Mehlville R-IX School District
2900 Lemay Ferry Road
St. Louis, Missouri 63125

SUBJECT: Addendum No. 3 to the Bidding Documents for:

Mehlville School District – Bus Transportation Facility Project

STL CO. #26PRJ-XXXXX
M.S.D. #26MSD-XXXXX
BASE MAP #28J3

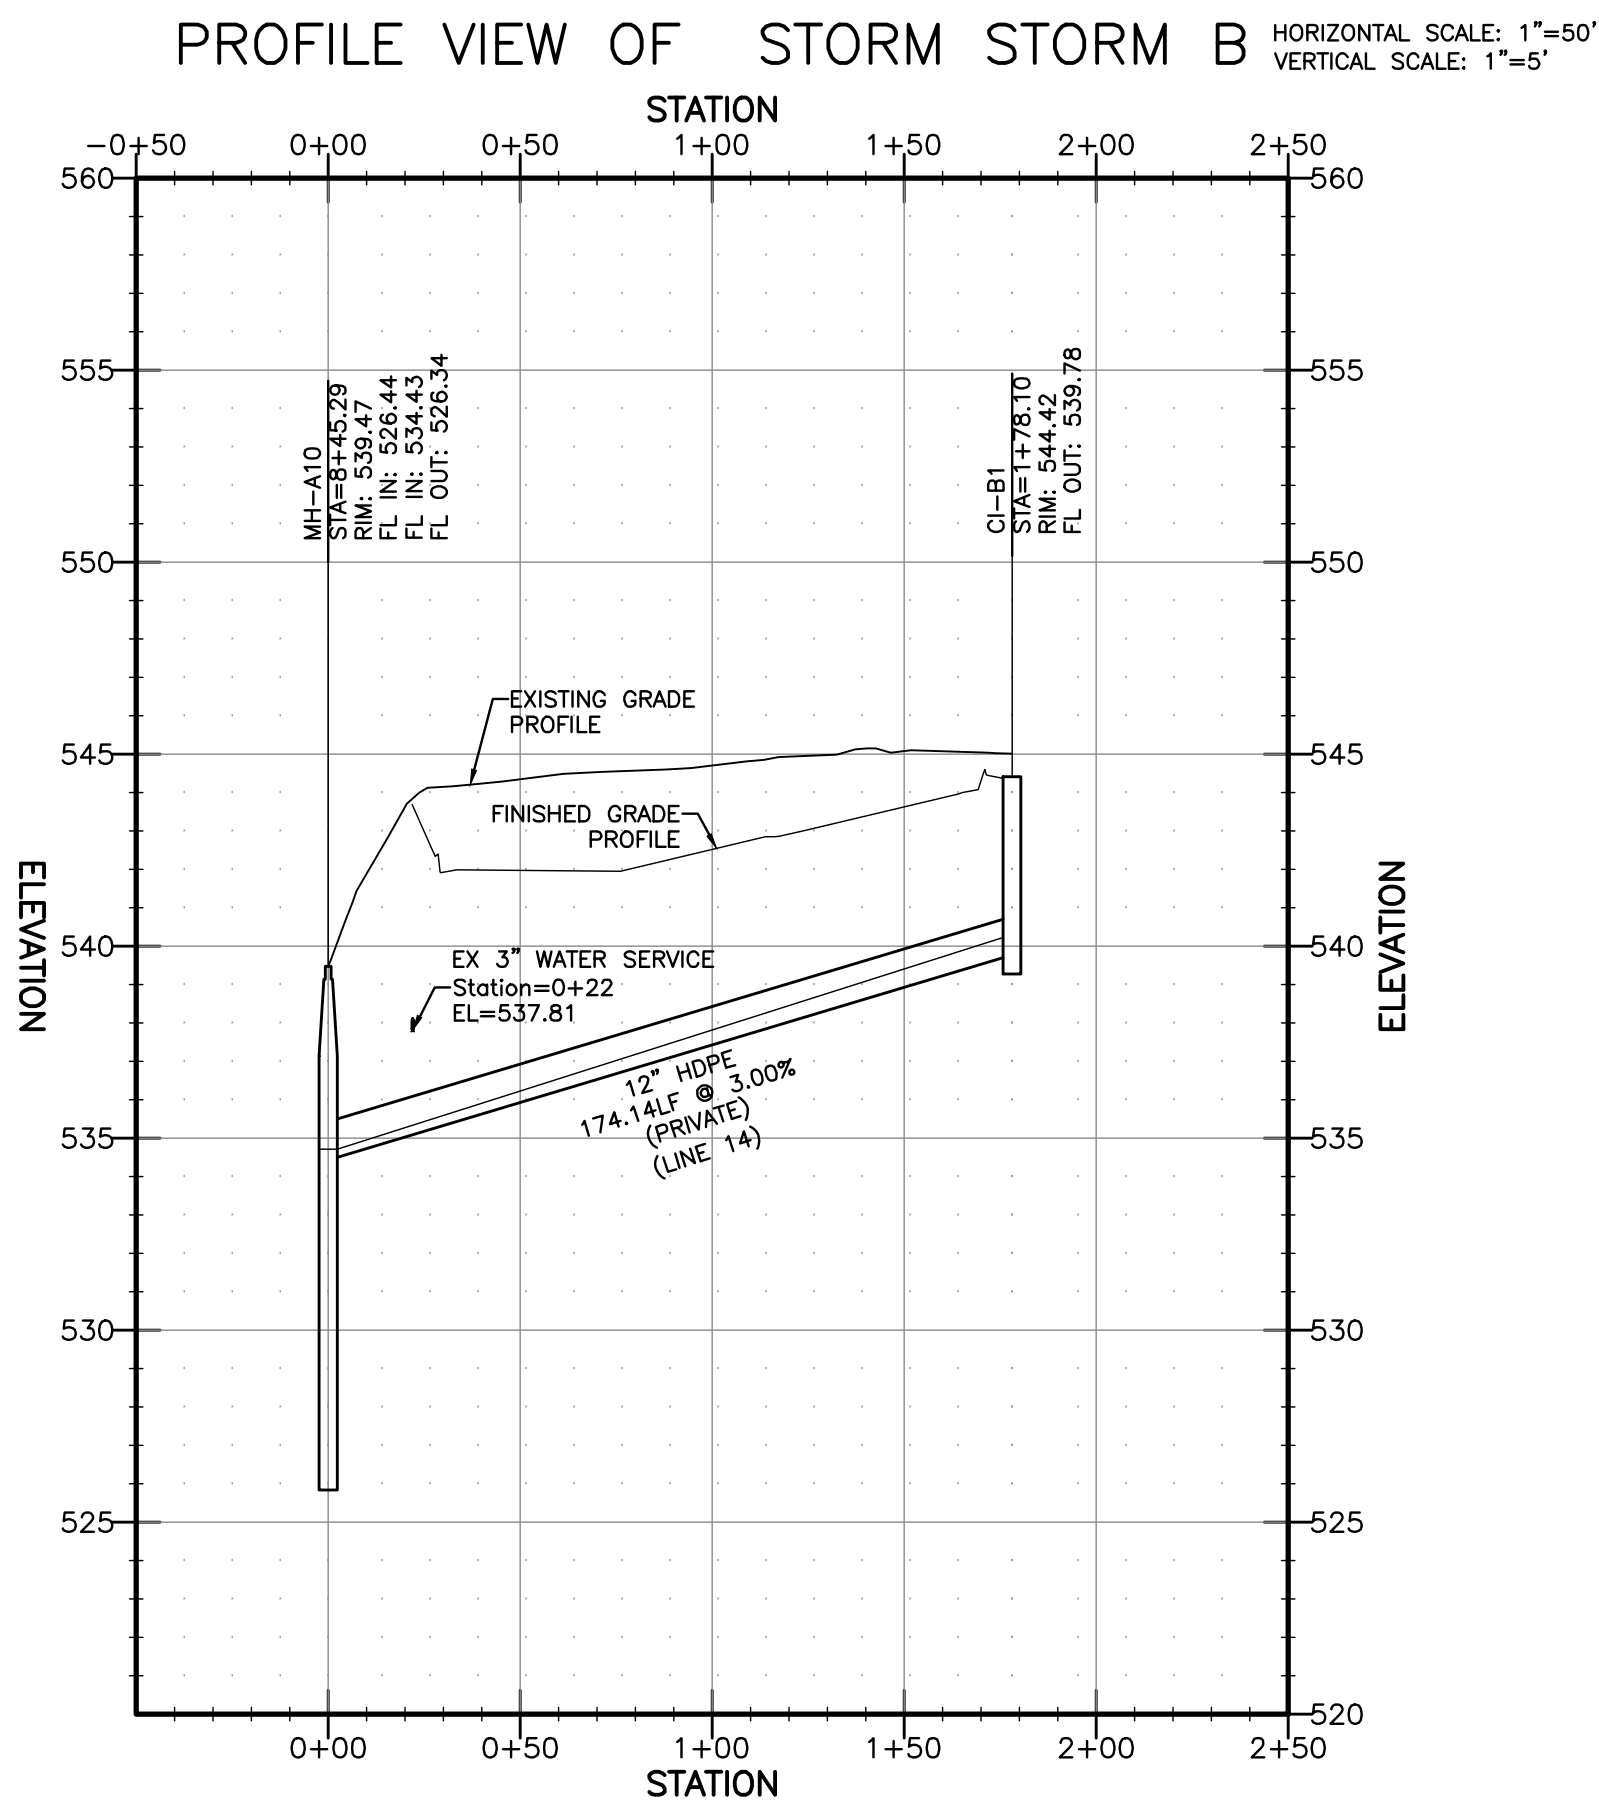
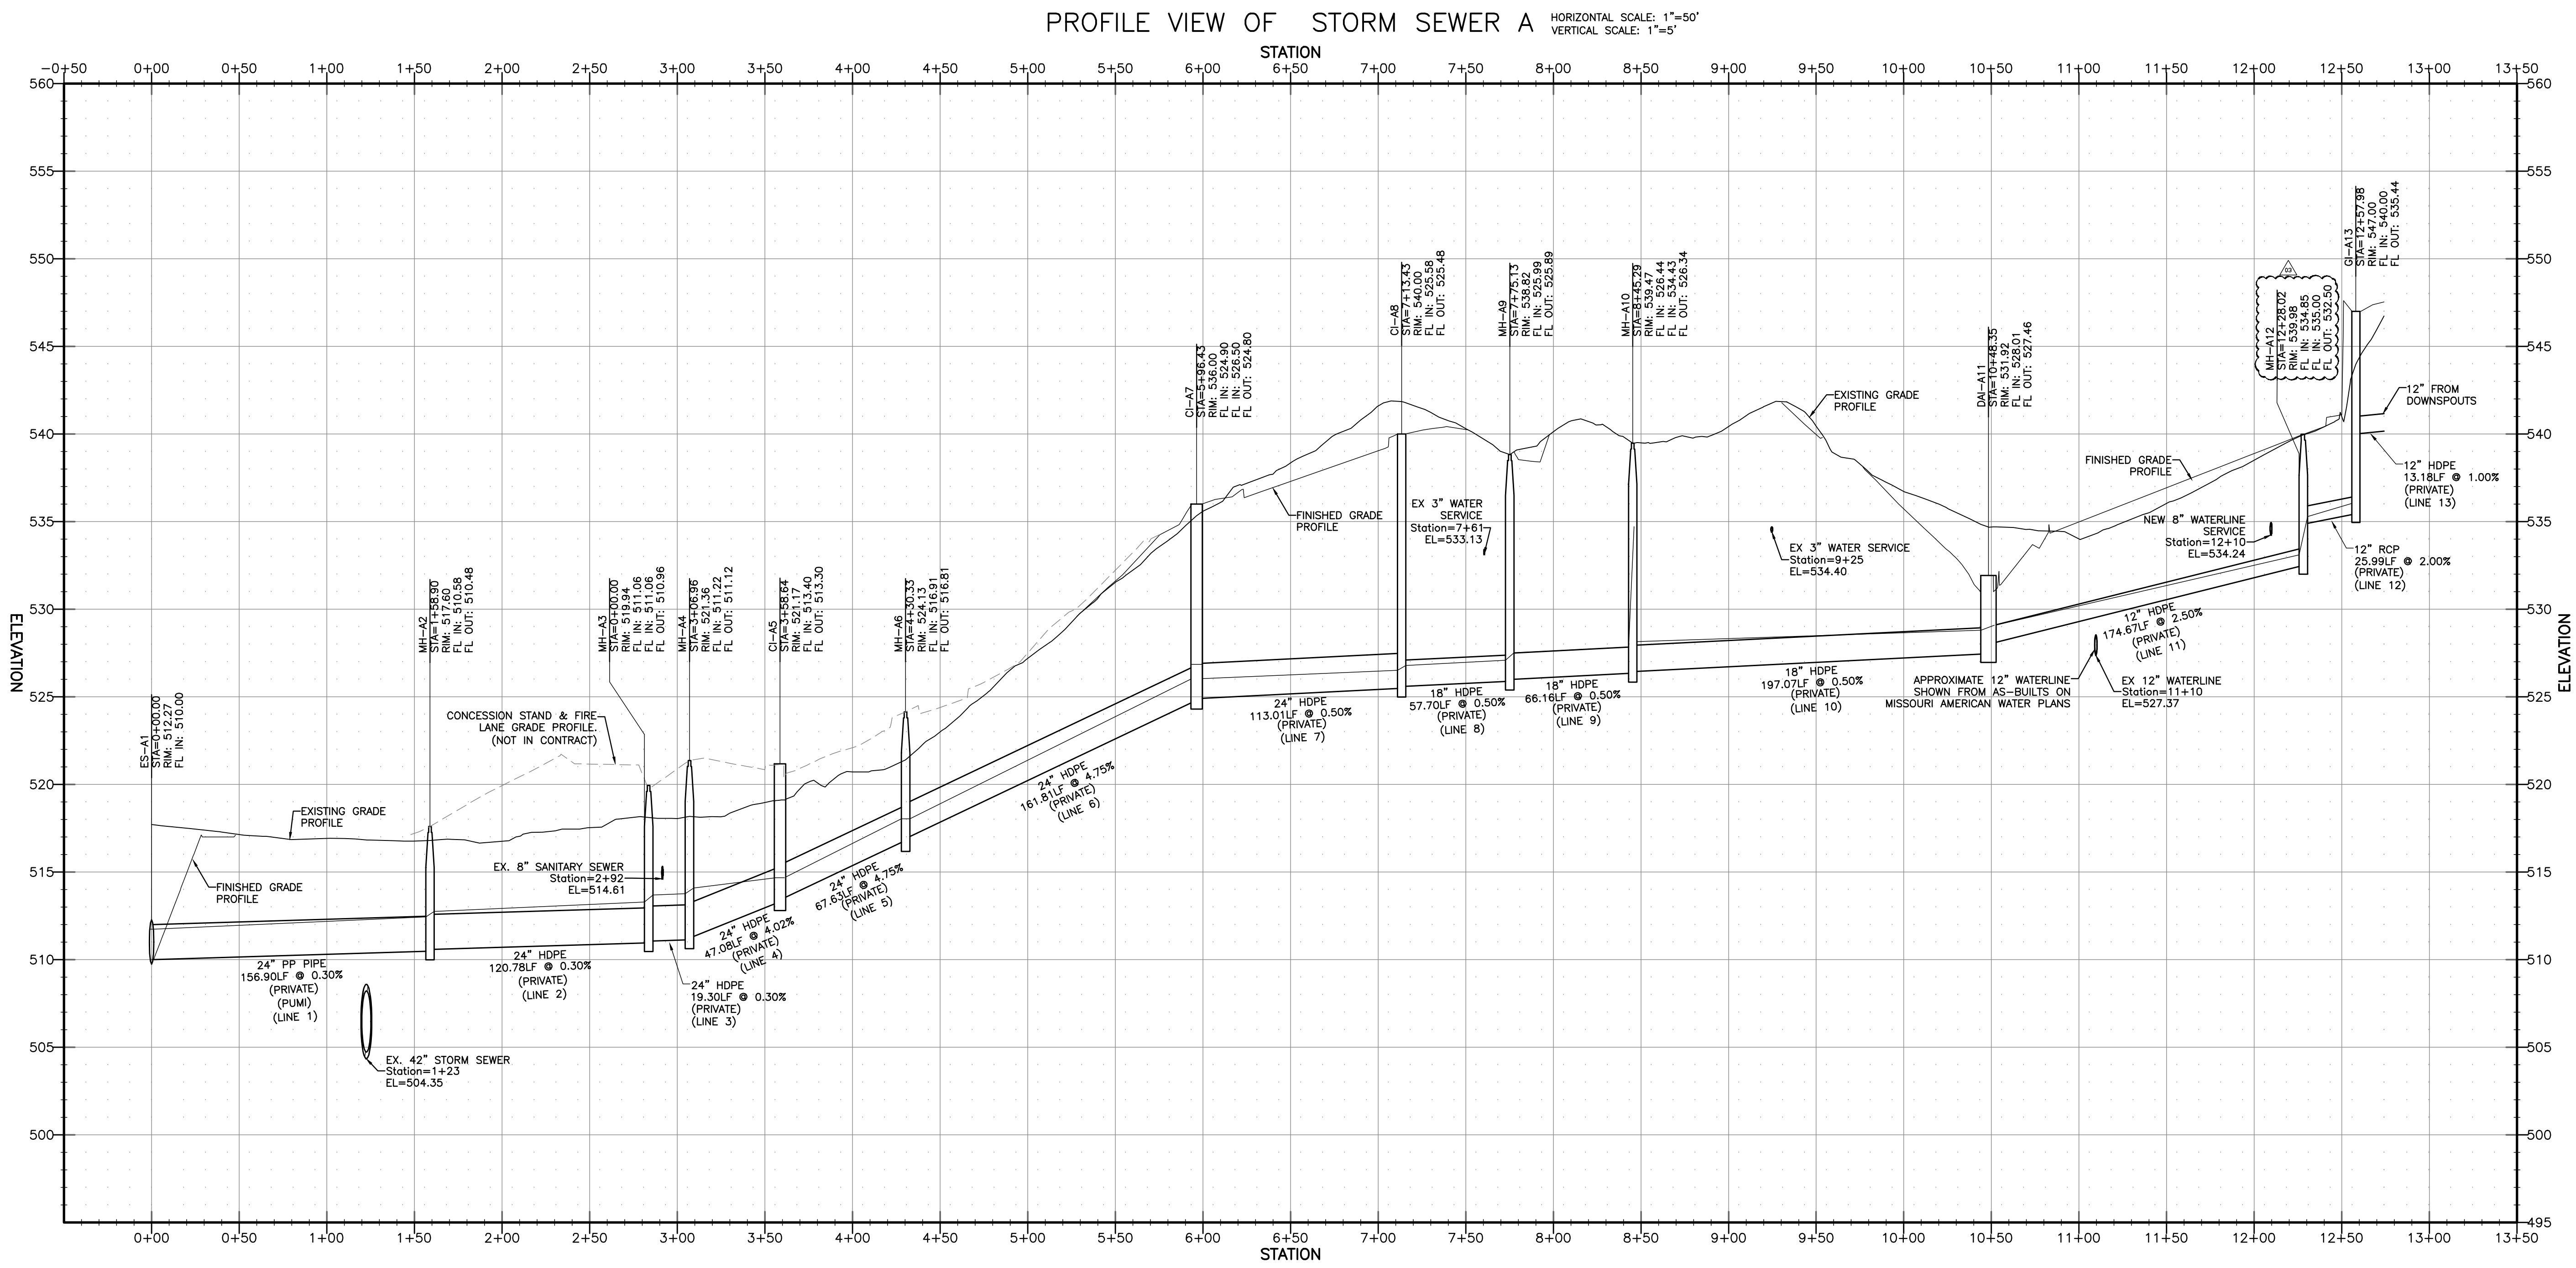
- a. **ADDED** foundation drain & tie in location to manhole
- 8. Sheet C5.0 - PROFILES SHEET
 - a. **UPDATED** profile callouts for new foundation drain connection to manhole

PH1.0

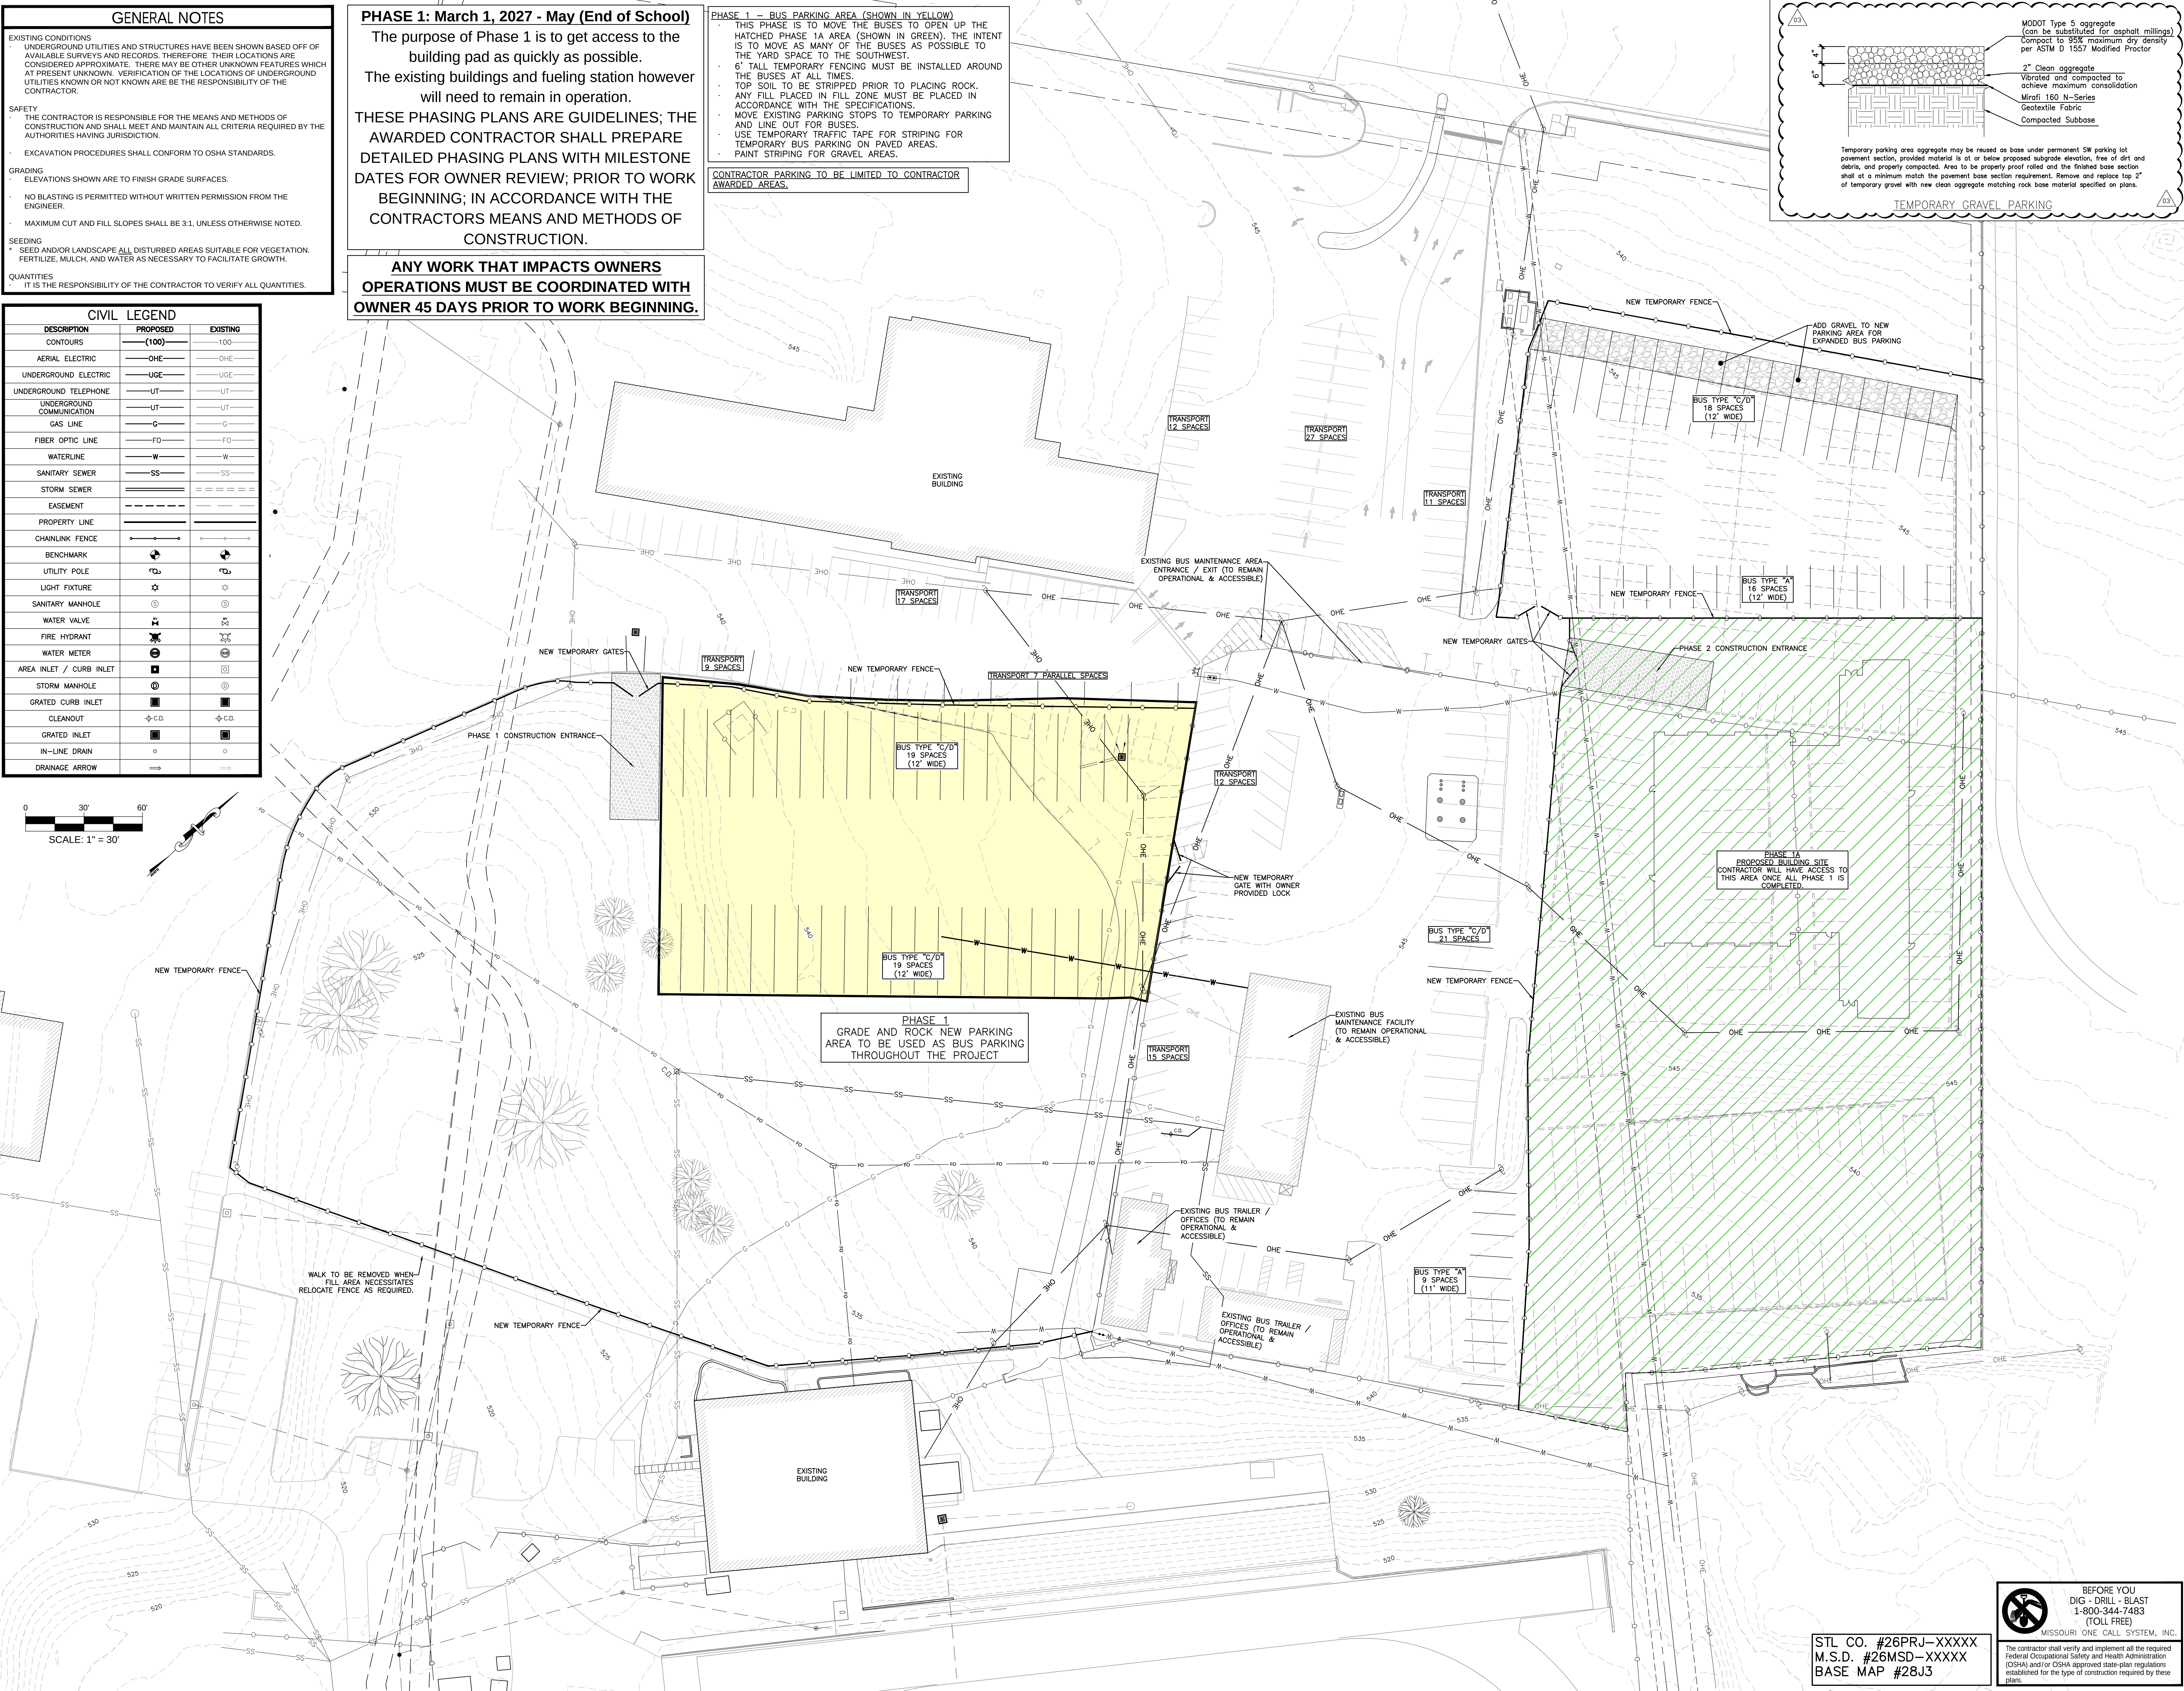
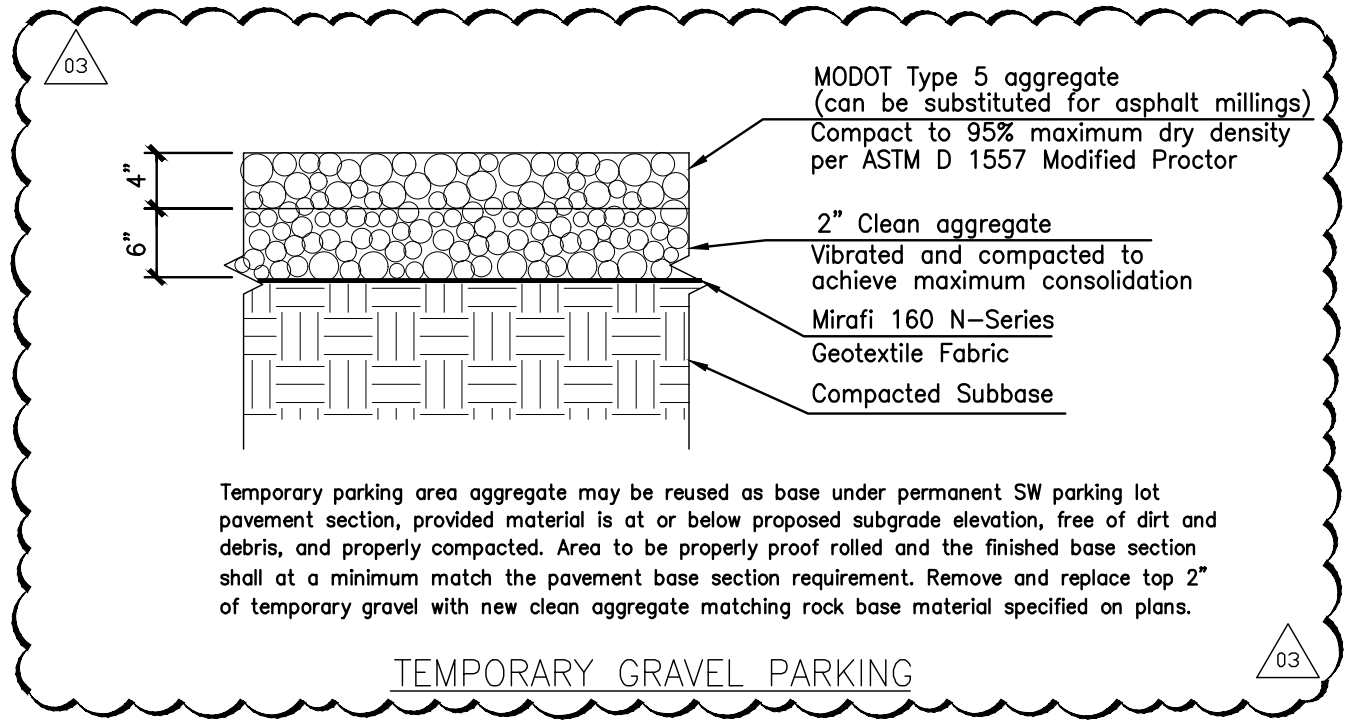
- 9. Sheet PH1.0 - PHASE 1 CIVIL PLANS
 - a. **ADDED** temporary gravel paving section & verbage dictating requirements for temporary rock parking to be used as base for pavement section.
